UNITED STATES PATENT AND TRADEMARK OFFICE

APPLICATION NO.	FILING DATE	FIRST NAMED INVENTOR	ATTORNEY DOCKET NO.	CONFIRMATION NO.
10/797,950	03/10/2004	Toru Takuchi	42530-6800	4866

Office Action Summary

DETAILED ACTION

FIG. 10

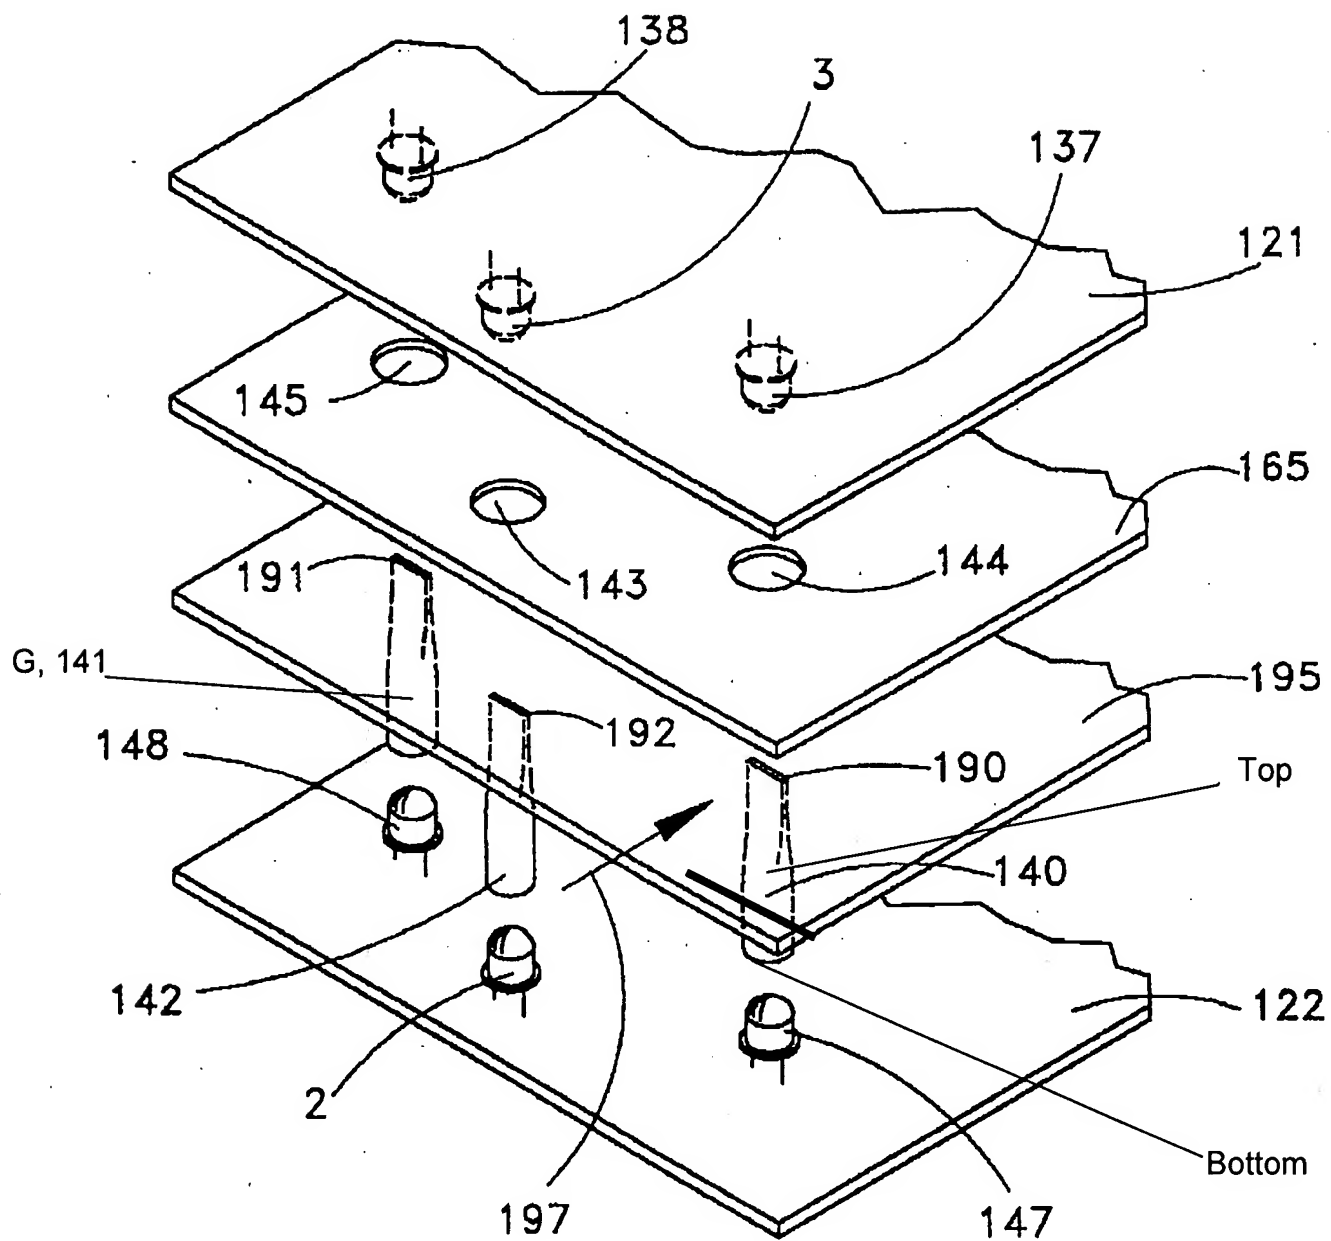
Claim 1: banknote storing unit (21, 22); banknote receiving unit (103); pushers (4, 5); moving unit (M2); optical guide units (See FIG. 10 below, 140, 142, G); light projecting surface (190-192); light receiving surface (See FIG. 10 below, 140, 142, G); surface (195); optical emitter-receiver pair units (See FIG. 10: 2, 147, 148; 3, 137, 138); light emitting element (See FIG. 10: 2, 147, 148); light receiving element (See FIG. 10: 3, 137, 138);

Claim 2: detecting projecting surface (See FIG. 10 below: top of 140, 142, and G); receiver section (See FIG. 10 below, curved sections of 3, 137, 138); optical emitter-receiver pair unit (See FIG. 10: 2, 147, 148; 3, 137, 138); detecting receiving surface (See FIG. 10 below: bottom of 140, 142, and G); emitter section (See FIG. 10 below, curved sections of 2, 147, 148);

Claim 3: detecting projecting surface (190-192); position detecting optical guide unit (See FIG. 10 below, 140, 142, G); light beam (column 8, lines 40-49); emitter section (See FIG. 10 below, curved sections of 2, 147, 148); position detecting emitter-receiver pair unit (See FIG. 10: 2, 147, 148; 3, 137, 138); reflector member (See FIG. 10 below: top of 140, 142, and G);

Claims 9: **optical guide unit** (140); **first column** (See FIG. 10 below, top of 140); **second column** (See FIG. 10 below, bottom of 140); **first end of the first column** (See FIG. 10 below, bottom end of top of 140); **first reflecting surface** (See FIG. 10 below, bottom end cross section of top of 140); **first end of the second column** (See FIG. 10 below, top end of bottom of 140); **second reflecting surface** (See FIG. 10 below, top end cross section of bottom of 140); **side surface of the first column** (See FIG. 10 below, inside surface of top of 140); **detecting projecting surface** (190); **side surface of the second column** (See FIG. 10 below, inside surface of bottom of 140); **detecting receiving surface** (See FIG. 10 below, inside surface of bottom of 140); **light projecting surface** (See FIG. 10 below, bottom surface of the bottom of 140);

Claim 12: second end of the first column (See FIG. 10 below, bottom end of bottom of 140); projecting surface (See FIG. 10 below, bottom surface of the bottom of 140);

Claim 25: optical guide assembly (142); first reflecting surface (See FIG. 10 below, bottom end cross section of top of 140); second reflecting surface (See FIG. 10 below, top end cross section of bottom of 140); light projecting section (2); light receiving section (3);

FIG. G1

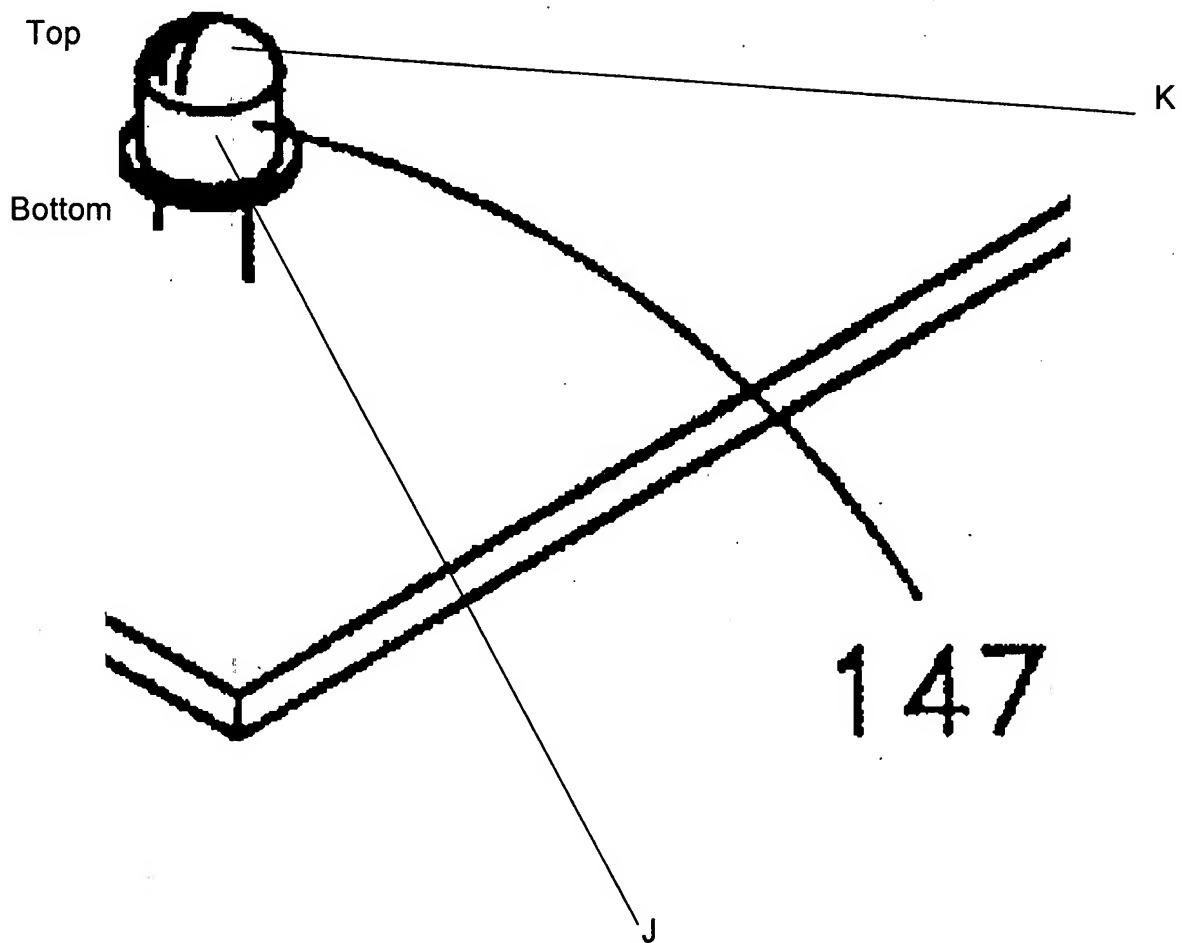
Claim 11: **emitter** (147); **light** (column 8, lines 40-49); **first cylinder** (See FIG. G1 below, J); **first end of the first cylinder** (See FIG. G1 below, top of J); **second end of the first cylinder** (See FIG. G1 below, bottom of J); **receiver** (137); **second cylinder** (See FIG. G2 below, H); **second end of the first cylinder** (See FIG. G2 below, bottom of H); **portion of light** (144 and column 8, lines 40-49); **second end of the second cylinder** (See FIG. G2 below, top of H);

Claim 24: projecting and receiving unit (2, 3); cylinders (See FIG. G1 below, J;
See FIG. G2 below, H); first cylinder (See FIG. G1 below, J); one end of the light

Claim 29: first and second cylinder (See FIG. G1 below, J; FIG. G2 below, H; respectively); one piece (See FIG. G1 below, J; FIG. G2 below, H);

FIG. G2

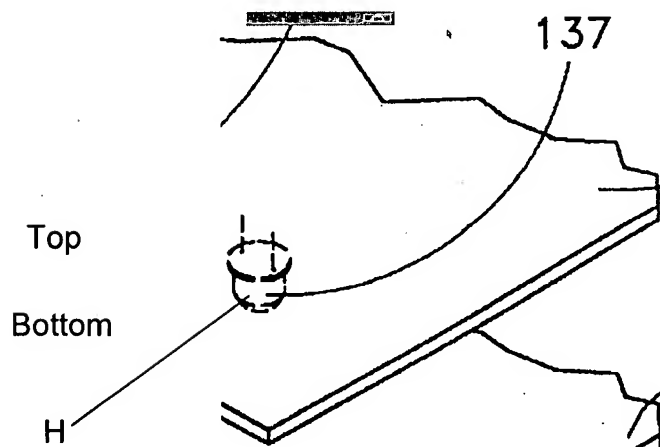
emitting element (See FIG. G1 below, top of J); second cylinder (See FIG. G2 below, H); one end of the photo-detection element (See FIG. G2 below, bottom of H);
